# HERITAGE HIGH SCHOOL NEW CLASSROOM BUILDINGS, INCREMENT 2. Bid Clarification 02

May 25<sup>th</sup>, 2021

DSA File Number: 7-H4  
DSA Application Number: 01-119268  
PTN: 61721-77

**Architect's Project No.:** 1870.00

**BC 02.06**

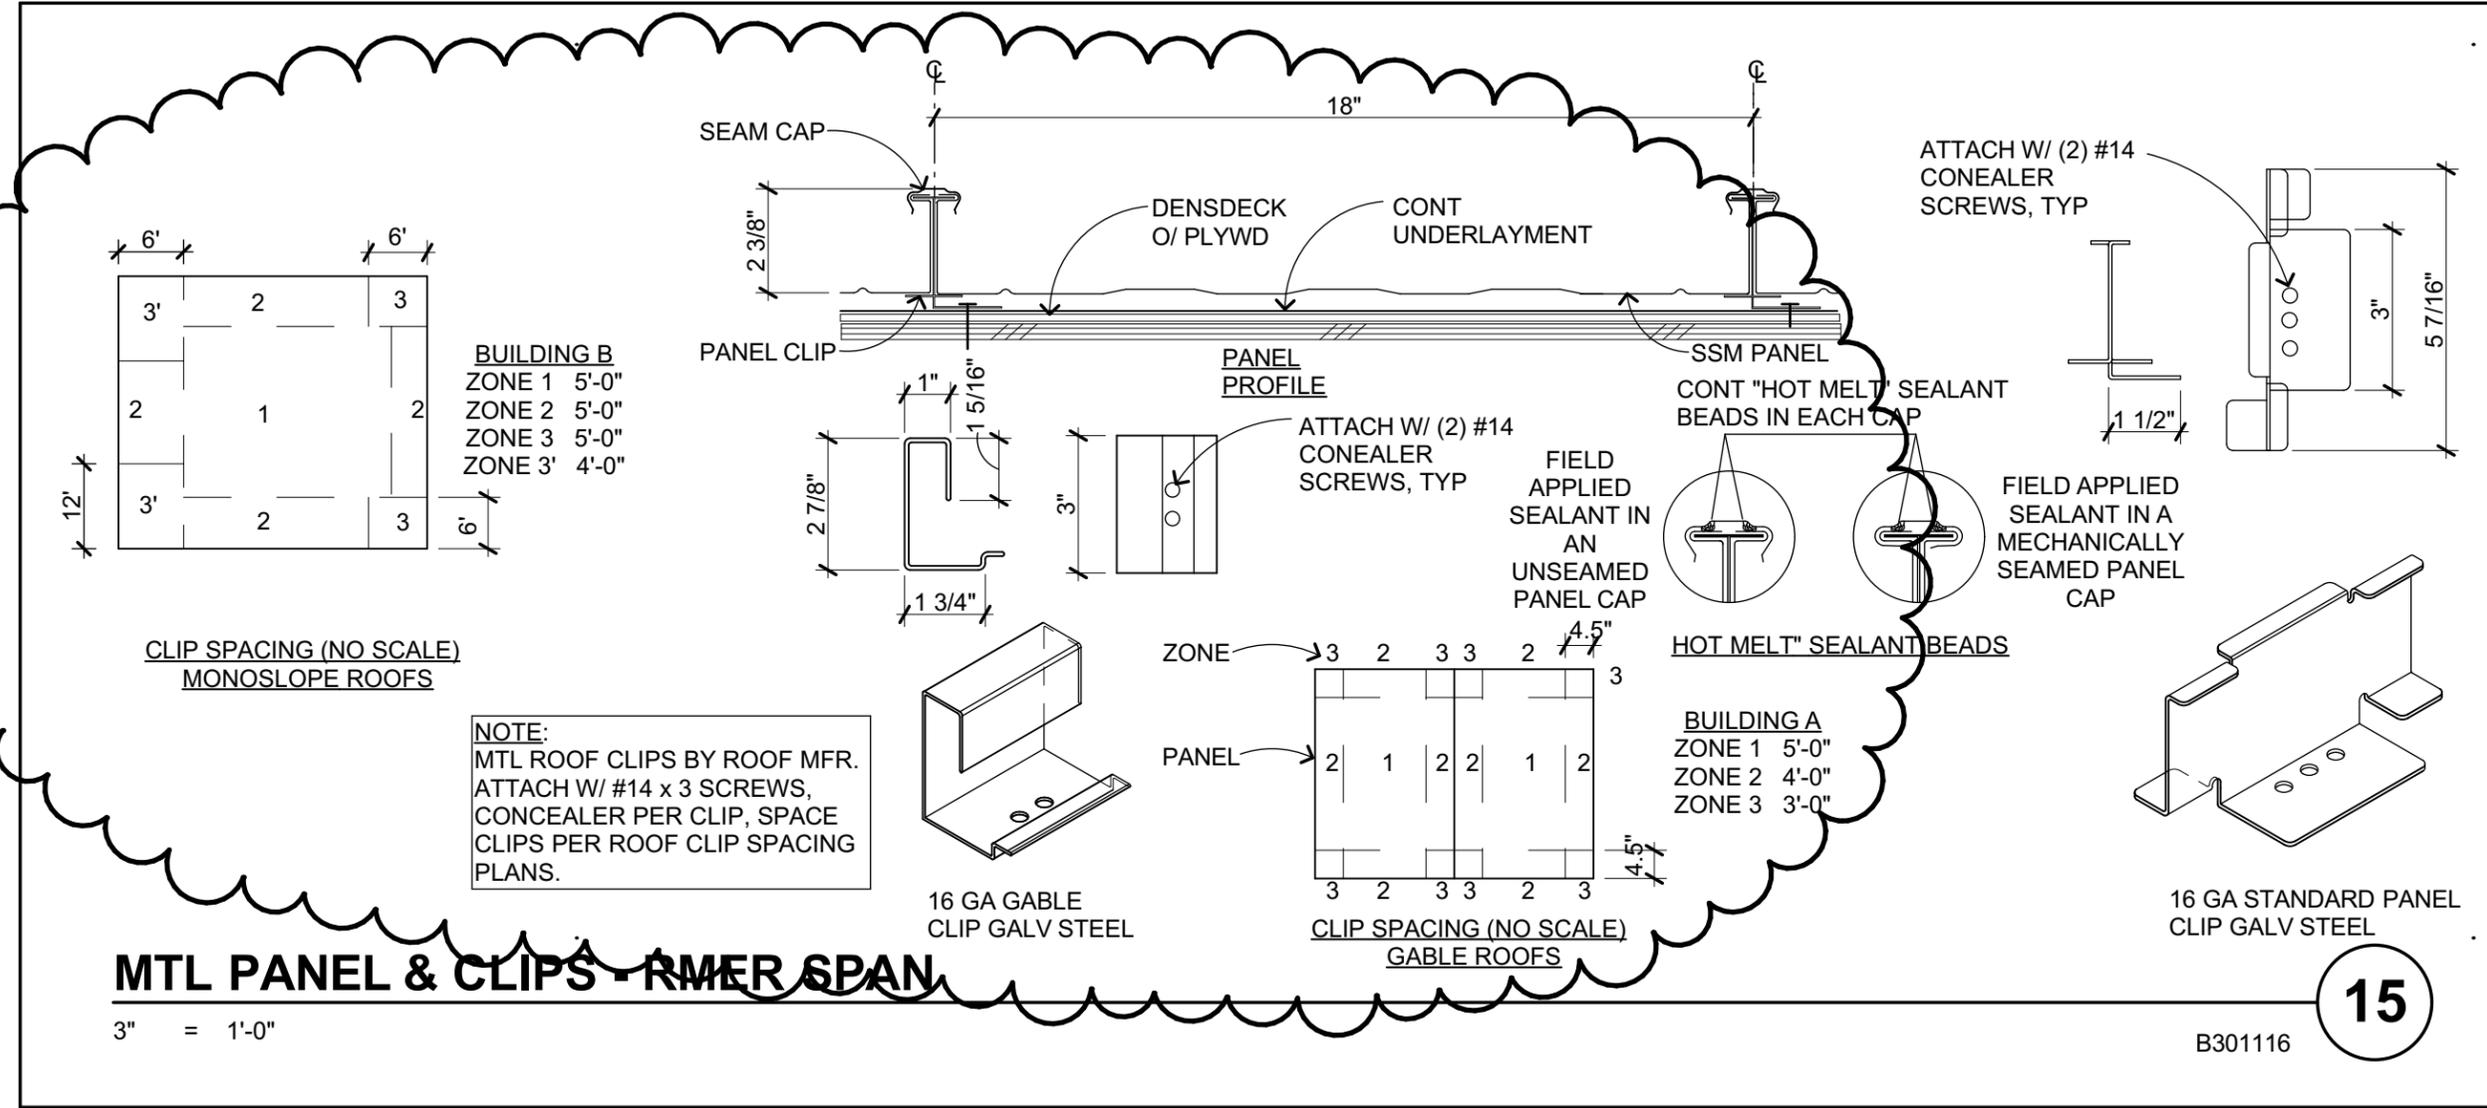
Sheet A-9.2 ROOF DETAILS  
Revise in accordance with the attached drawing BC 02.06.

**BC 02.07**

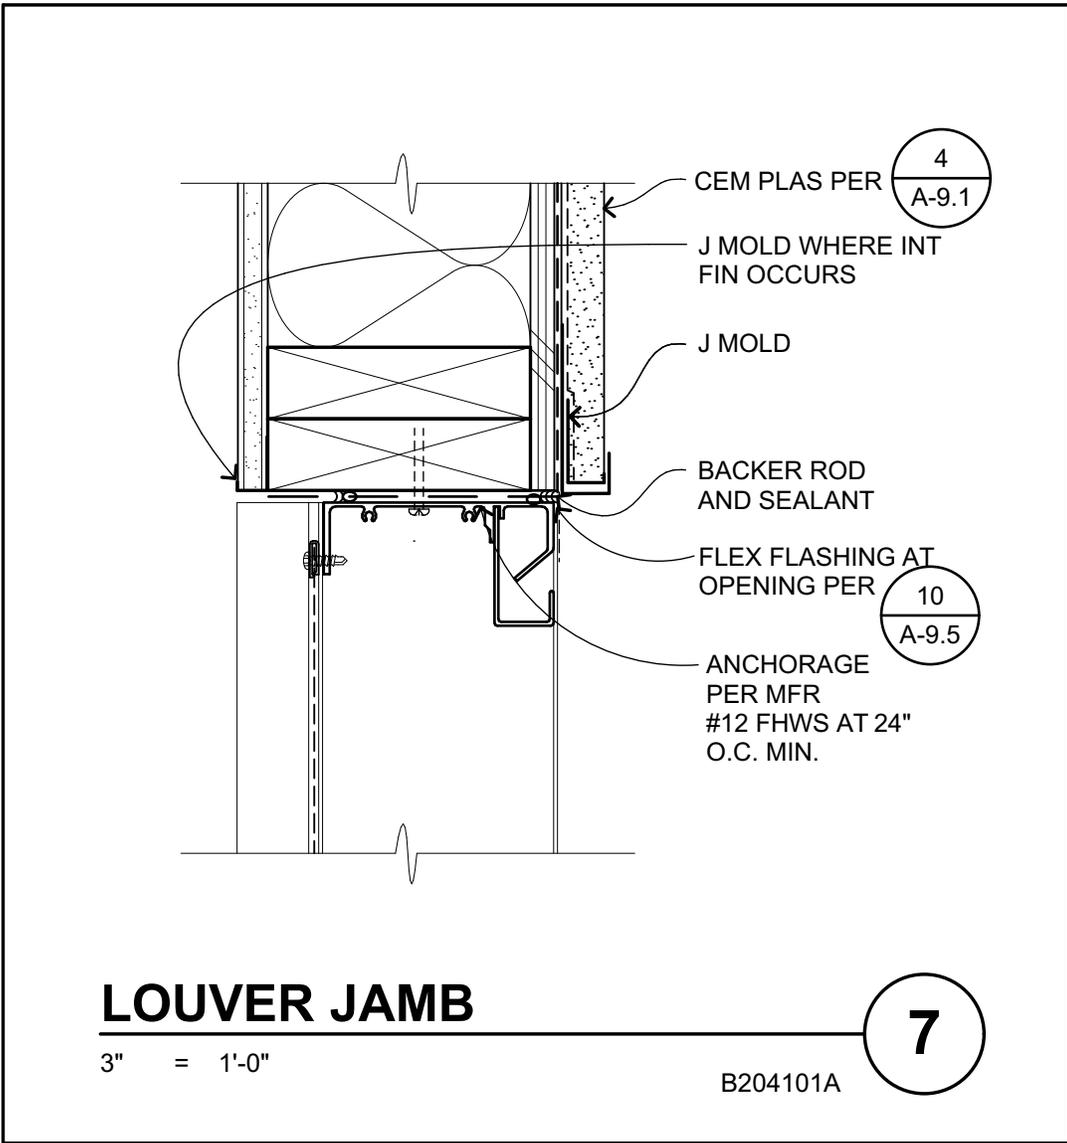
Sheet A-9.3 ROOF DETAILS  
Revise in accordance with the attached drawings BC 02.07.
